Access Compliance Report

Public Rights-of-Way

Intersection ID: 10032531	Main Street: N_COLLEGE_ST	Cross Street: N/A	Location: W
ADA ID: 3006B6BC8260	Ramp Type: PerpDiag	Initial Pass/Fail: Fail	Overall Compliance: No
Severity Score: 12.5			
Codes/Mitigation Info/Possible Solution		Field Measurements/Component Compliance

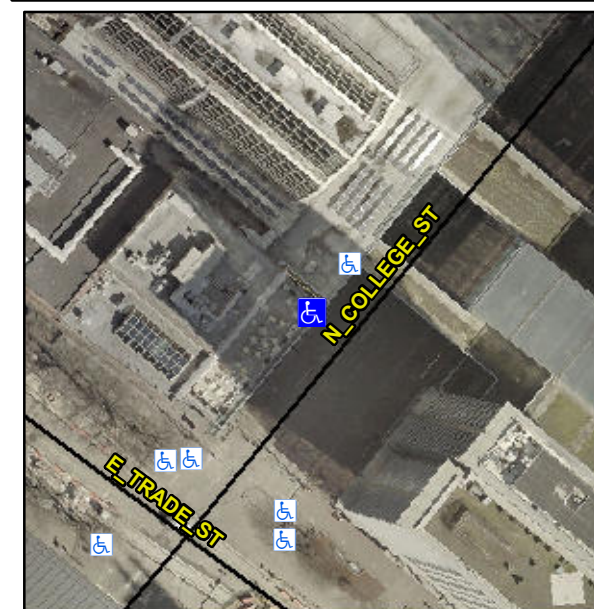
Not Found, R304.2.2

Compliance	Description	Data	Compliance	Description	Data
N/A	Ramp Length (in)	49.0	No	Ramp Slope (%)	9.3
Yes	Ramp Width (in)	48.0	Yes	Ramp XSlope (%)	1.1
N/A	Flare Type LT	N/A	N/A	Flare Type RT	N/A
N/A	Flare Slope LT (%)	N/A	N/A	Flare Slope RT (%)	N/A
N/A	Flare Traversable LT?	N/A	N/A	Flare Traversable RT?	N/A
N/A	Landing Length (in)	N/A	N/A	DWS Provided?	N/A
N/A	Landing Width (in)	N/A	N/A	DWS Contrast?	N/A
N/A	Landing Slope (%)	N/A	N/A	DWS Length (in)	N/A
N/A	Landing X Slope (%)	N/A	N/A	DWS Full Width?	N/A
N/A	Landing Curb? (Y/N)	N/A	N/A	DWS Offset (in)	N/A
N/A	Shared Landing?	N/A			
N/A	Gutter Ponding?	N/A	N/A	Gutter Slope (%)	N/A
N/A	Gutter Lip Ht (in)	N/A	N/A	Gutter X Slope (%)	N/A
N/A	Painted X Walk1?	No	N/A	Painted X Walk2?	Yes
	X Walk 1 Direction	To SE		X Walk 2 Direction	To NE
N/A	X Walk 1 Width (in)	N/A	N/A	X Walk 2 Width (in)	125.0
	X Walk 1 Slope (%)	3.5		X Walk 2 Slope (%)	1.1
	X Walk 1 X Slope (%)	1.7		X Walk 2 X Slope (%)	2.8

Remove & Replace Curb Ramp With Two New Directional Ramps or Equivalent.
